Corrective Action Plan
for CAU No. 426
Cactus Spring Waste Trenches
Tonopah Test Range

DOCUMENT REVIEW FORM

1. Document Title/Number: Preliminary Draft Corrective Action Plan For CAU 426, Cactus Spring Waste Trenches, Tonopah Test Range	2. Document Date: 8/12/97
3. Revision Number: 0	4. Originator/Organization: Dave Madsen, BN/RP, M/S NTS306
5. Responsible DOE/NV ERP Task Manager: Kevin Cabble	6. Review Criteria: Technical
7. Reviewer/Organization: Karen Beckley, NDEP

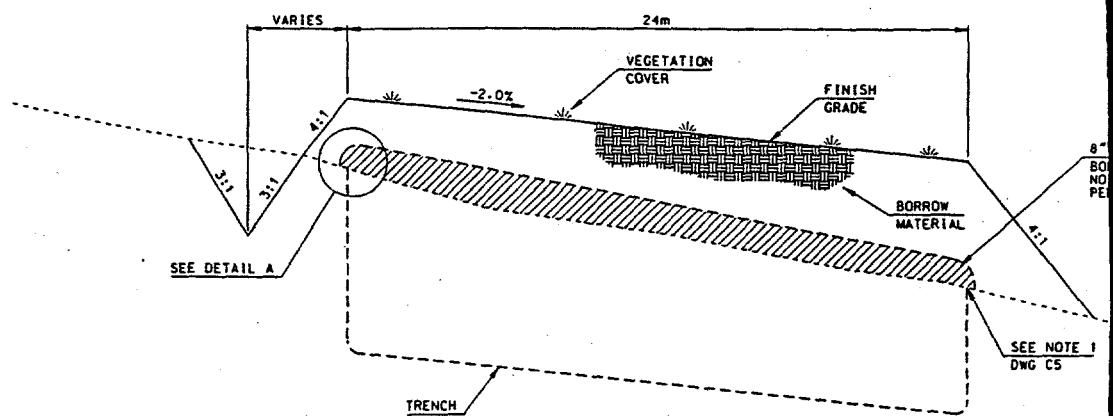
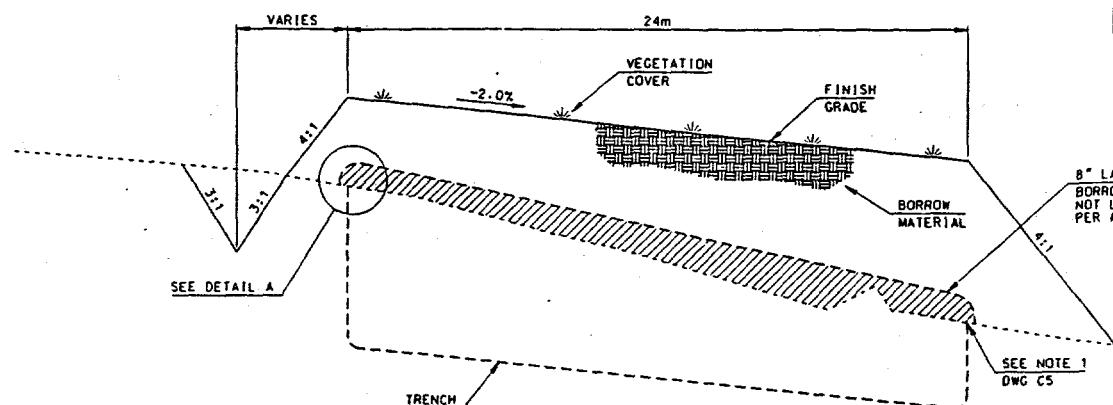
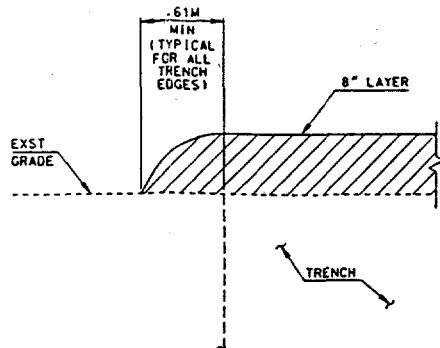
4. Appendix B	M	The last engineering drawing, which shows the design specification of the fill/capping activities, suggests that the caps on the trenches do not exceed the actual trench. While this drawing clearly states, Not for Construction the implication is that the appropriate minimum cap dimensions in excess of the trench dimensions has not been considered. Minimum dimensions must be shown on the drawings.	The engineering drawings were changed to illustrate the cap coverage of the trench areas and minimum dimensions were added. The Title III drawings (Approved for Construction) are included in the Final Corrective Action Plan (this document).
